Assessment of Dam Safety

Coal Combustion Surface Impoundments (Task 3)

Final Report

American Electric Power
General James Gavin
Power Plant
Cheshire, Ohio

BOTTOM ASH POND SLOPE STABILITY
RAPID DRAW-DOWN STATE
GENERAL JAMES GAVIN POWER PLANT
AMERICAN ELECTRIC POWER
CHESHIRE, OHIO

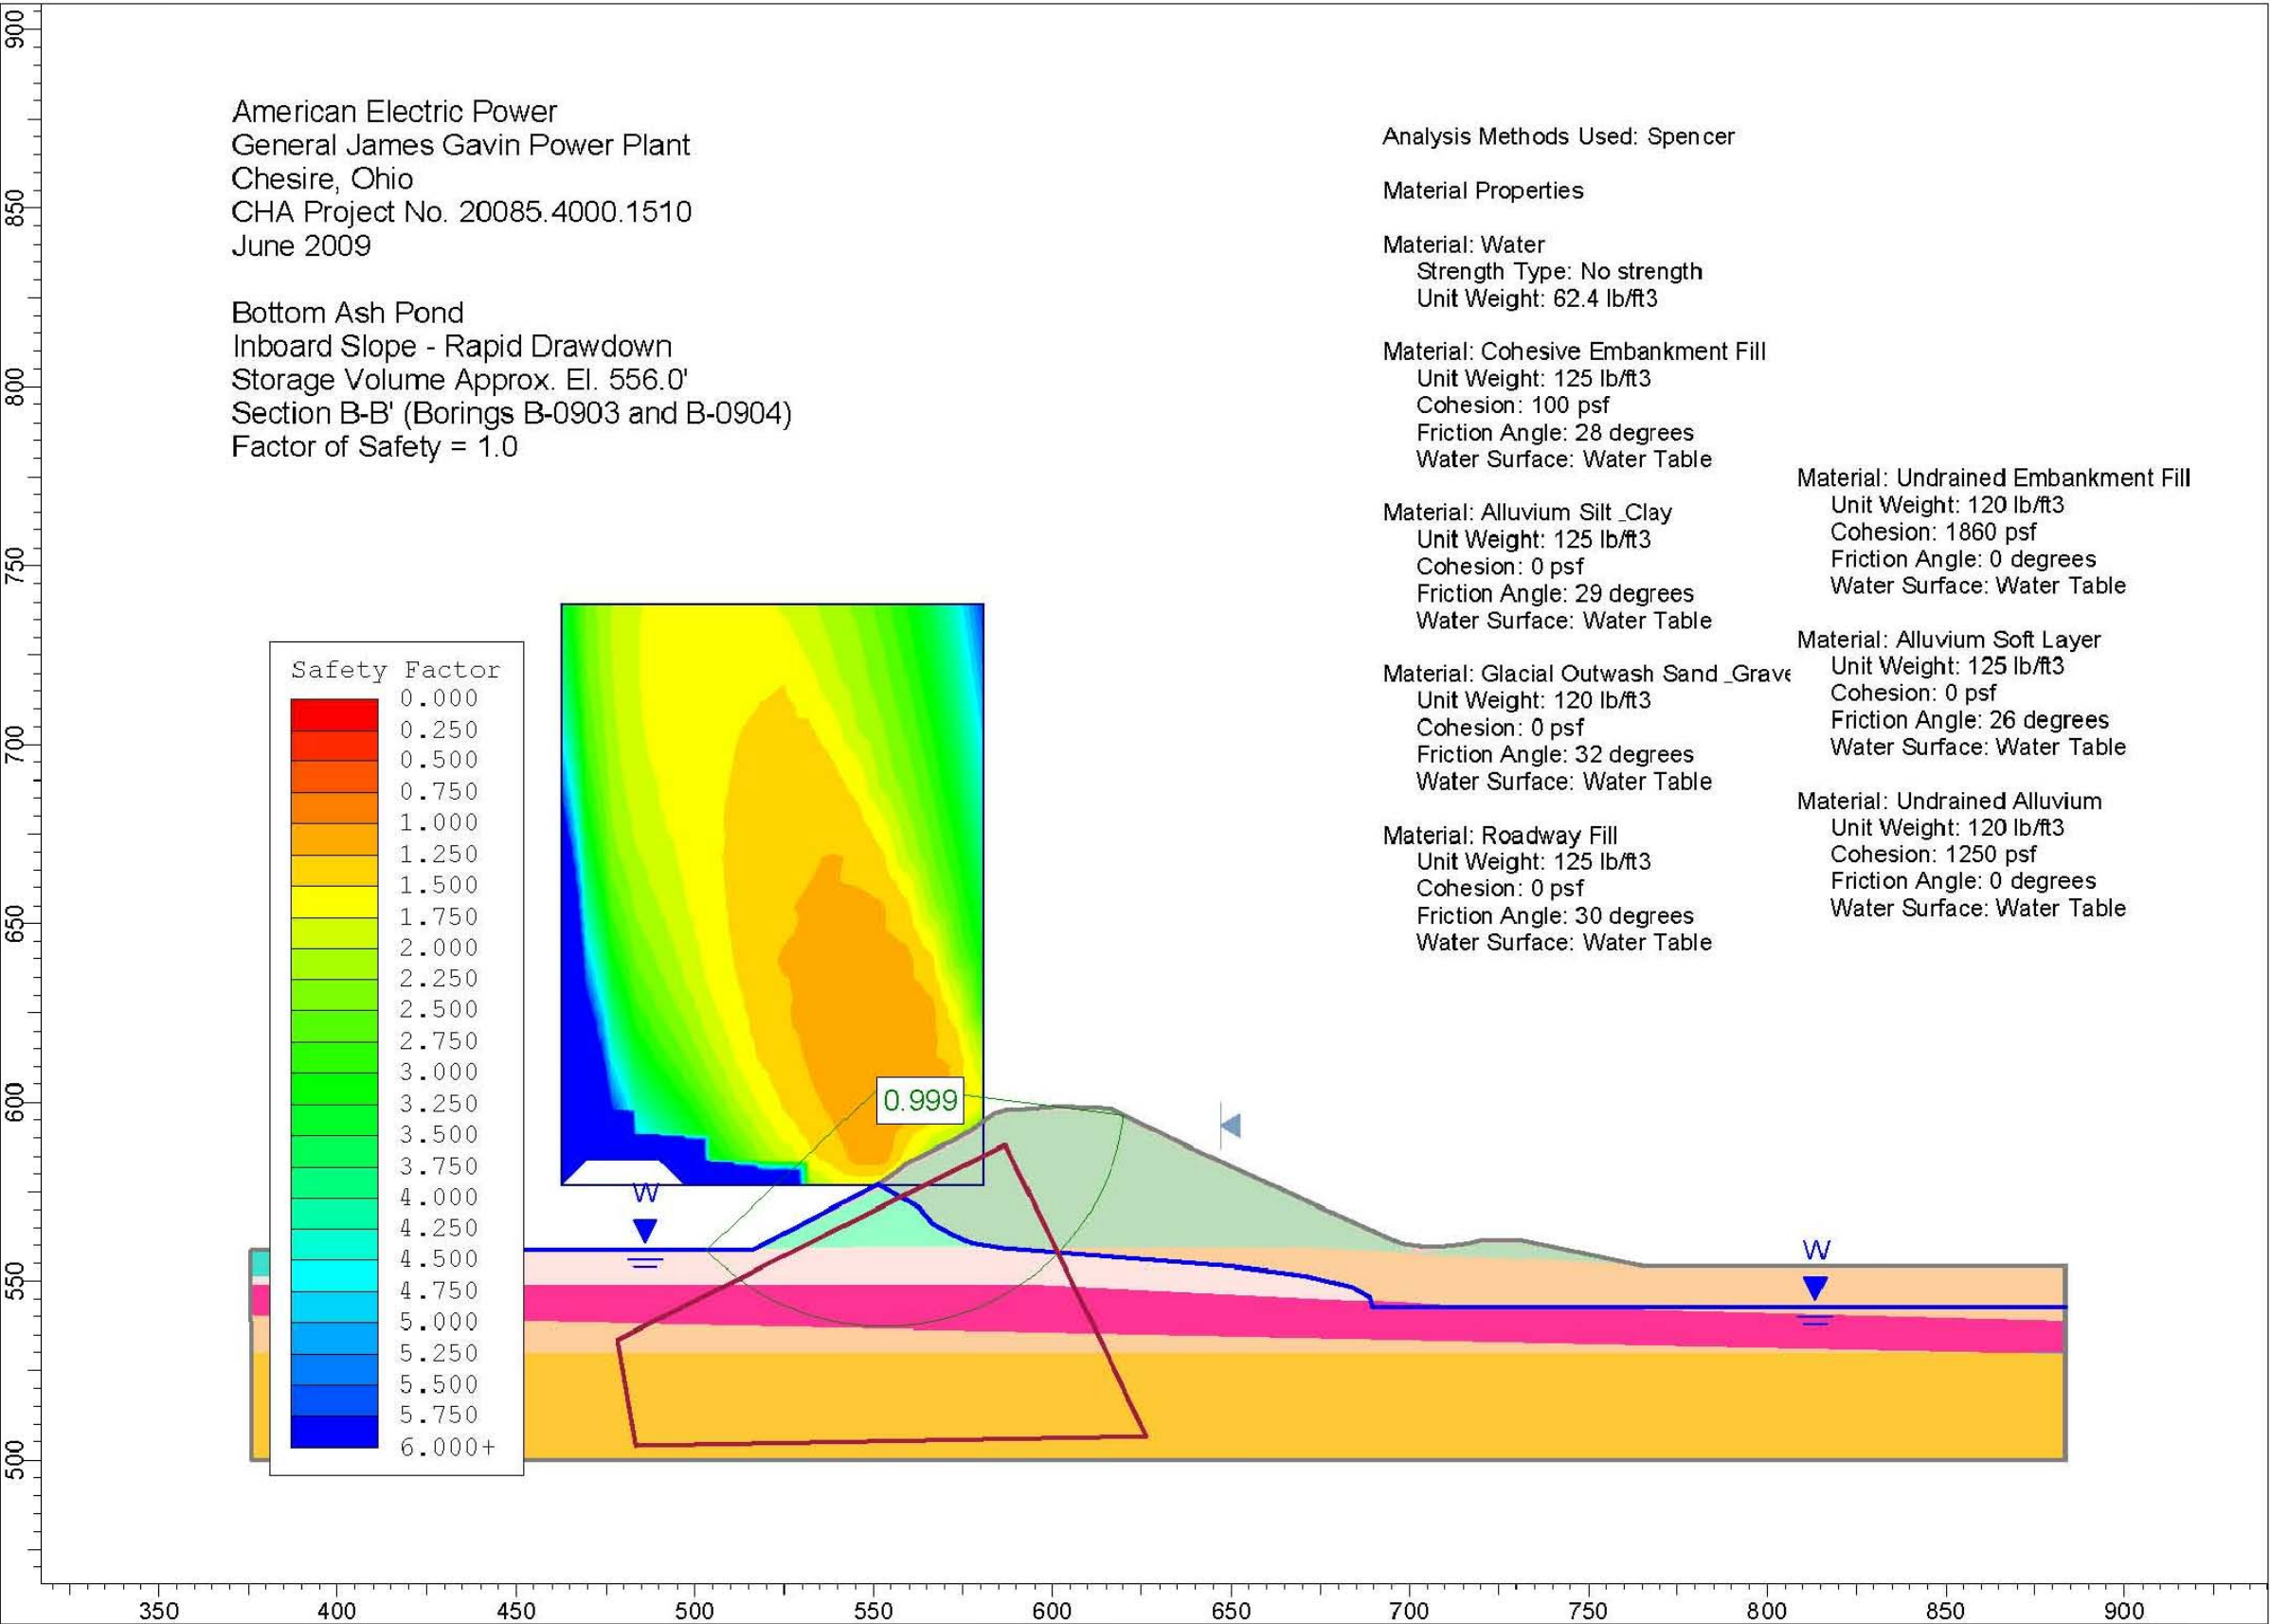
- The rapid-draw down load case was not evaluated as part of the June 2009 investigation. CHA modeled the south embankment slope using a combination of soil parameters provided in the June 2009 investigation report and parameters which may more closely represent field conditions (i.e. undrained embankment and alluvium soils on the upstream slope and a softer alluvium silt/clay layer). Figure 9C indicates that the calculated factor of safety for the rapid draw-down load condition is close to 1.0, which is below the minimum required value of 1.3 (according to the USACOE).
